THERESA-MICHAEL KOCH
P.P.# 7A-020-015
3.9184 AC.

Reviewed and Accepted
LAKE COUNTY GENERAL HEALTH DISTRICT
Date 11-6-95
see adjustments
JOEL LUCIA, R.S., M.P.H.
Health Commissioner
BY J. Lindsay

SITE PLAN FOR: MIKE & TERRY KOCH
45 MELROSE DR. PAINESVILLE, OHIO 357-8251

TRENCH DETAIL

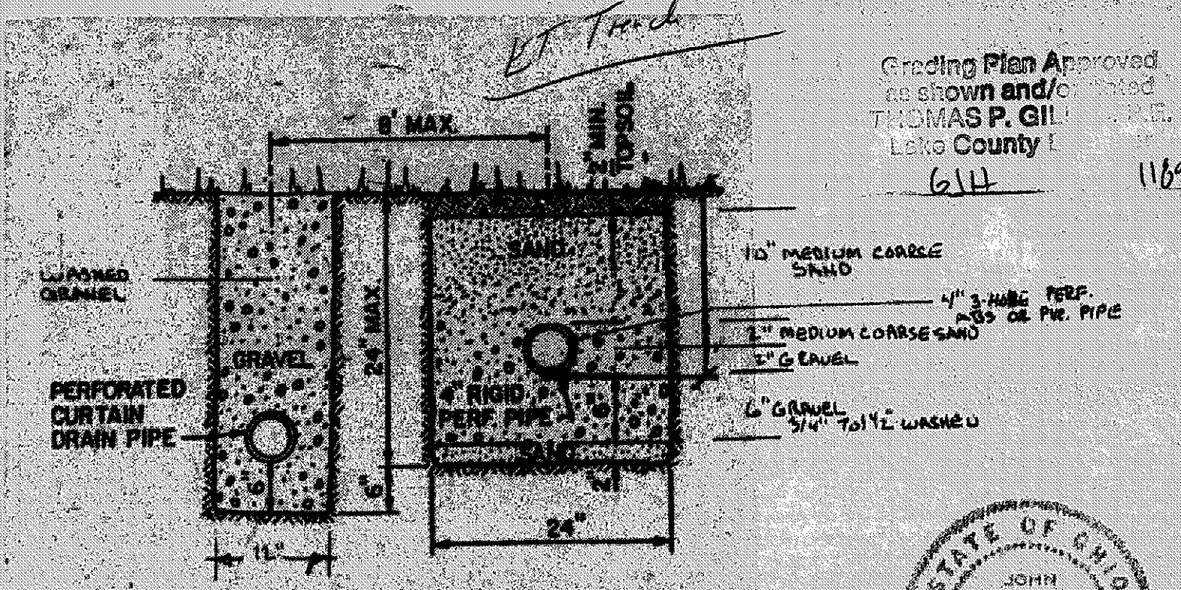
GRINDER PUMP TO BE INSTALLED IF BATHROOM IS CONSTRUCTED IN BASEMENT PUMP AS PER L.C.D.H.

REVISIONS
⚠ NOV-1-95 DELETE PUMP CHAMBER MAKE TNKS. SHOW ELEV. C. DRAINS. FTG. DRAINS STATION OUT

A. To be brought to finished grade
1. Septic tank manhole covers
2. Splitter box cover
3. Distribution box cover
B. No footer drains or downspouts to be discharged into septic tanks
C. All waste water to be discharged into septic tanks
